DUPRO INSPECTION REPORT

Factory : VEDHU INDUSTRIES

PURCHASE ORDER NO.
PO81714

ITEM DESCRIPTION
SMART LOCK

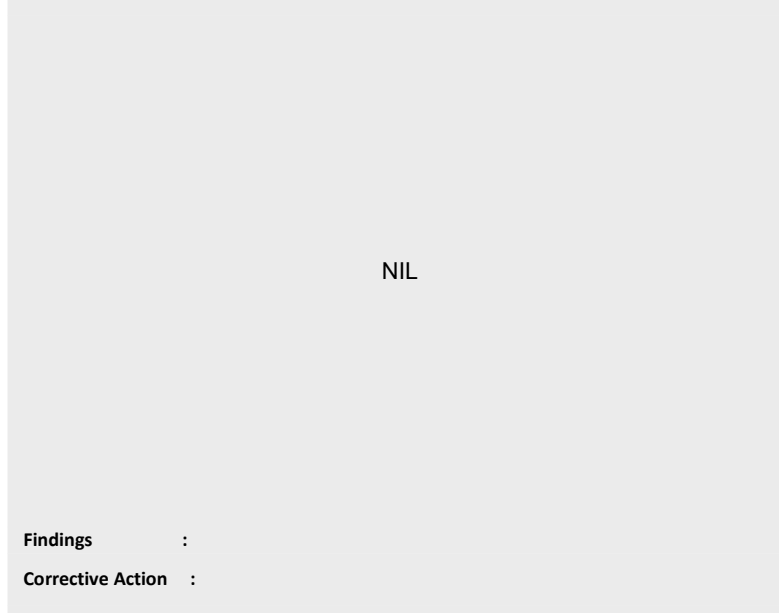
Findings : Scratch Mark at Body

Corrective Action : Avoid Scratch Mark and take utmost care while handling

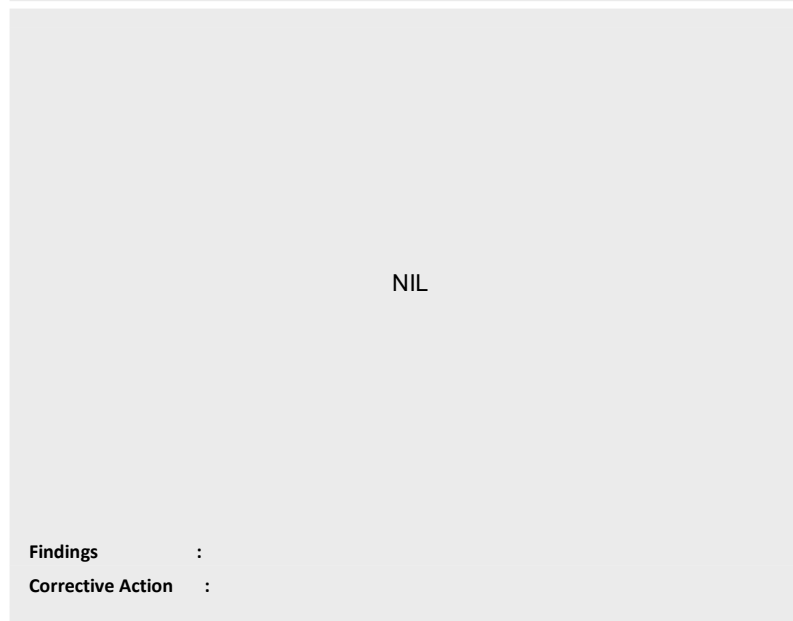
Findings : Stain Mark at Body

Corrective Action : Please avoid the stain mark.
